# UNITED STATES PATENT AND TRADEMARK OFFICE

| APPLICATION NO.  | FILING DATE | FIRST NAMED INVENTOR | ATTORNEY DOCKET NO.            | CONFIRMATION NO. |
|--|-------------|----------------------|--------------------------------|------------------|
| 10/663,438   | 09/16/2003  | Derrek William Batty | U 014818-3                     | 1568             |

| <b>Office Action Summary</b> | <b>Application No.</b>         | <b>Applicant(s)</b>   |  |

## DETAILED ACTION

FIG. 1

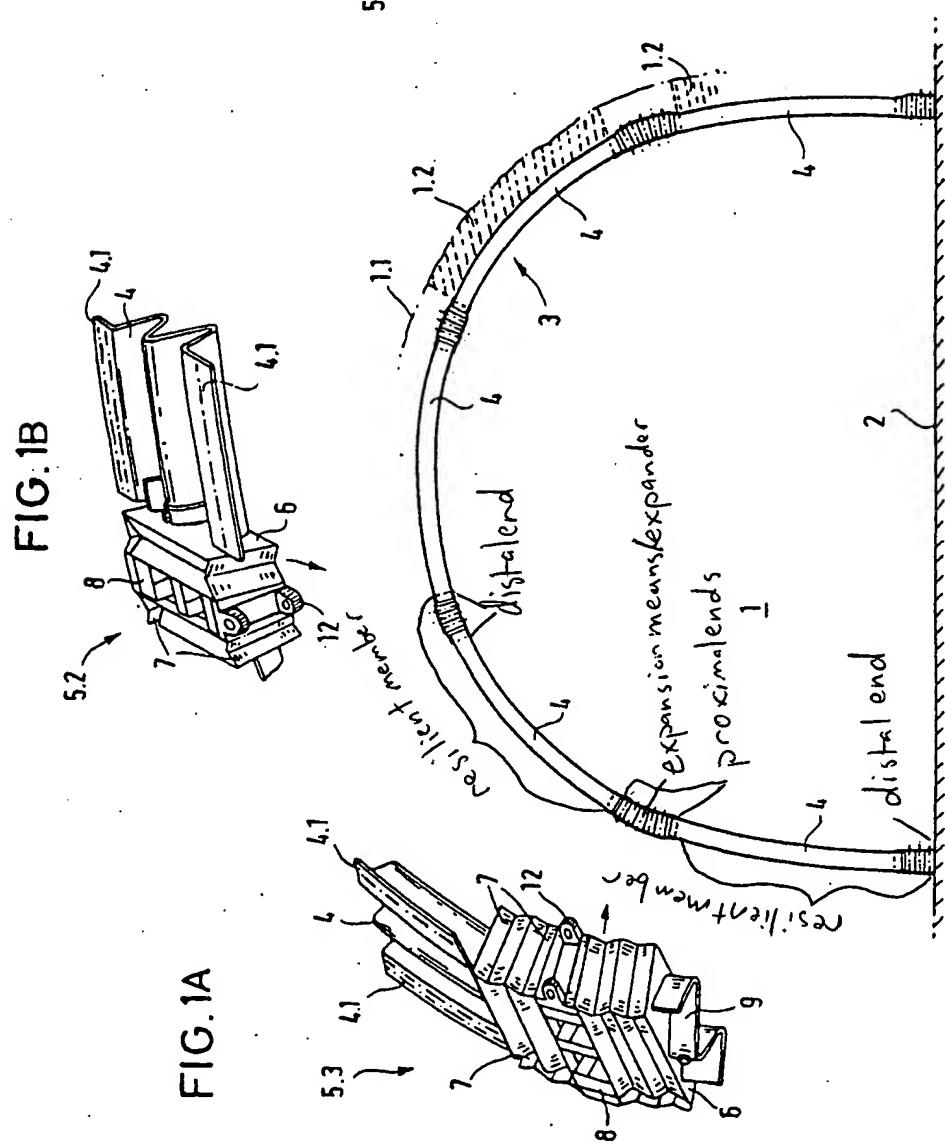
Schönfeld et al. disclose a support device (1, Fig. 1) for a rib (1.2, Fig. 1) between a floor (2, Fig. 1) and a roof (1.1, Fig. 1), the device including an expansion means (see marked figure); and a pair of resilient members (see marked figure) each having a proximal end (see marked figure) adapted for connection to the expansion means and a distal end (see marked figure) curved away from the expansion means and adapted for engagement with the floor and roof respectively, wherein when the device is positioned towards or against the rib and the expansion means is activated to drive the members apart, the members' distal ends are driven substantially vertically

into engagement with the floor and the roof and a portion (expansion means) of the device is driven substantially laterally into abutment against the rib.

Schönfeld et al. disclose a support device (1, Fig. 1), the device comprising an expander (see marked figure); and a pair of resilient members (see marked figure) each having a proximal end (see marked figure) adapted for connection to the expander and a distal end (see marked figure) curved away from the expander.
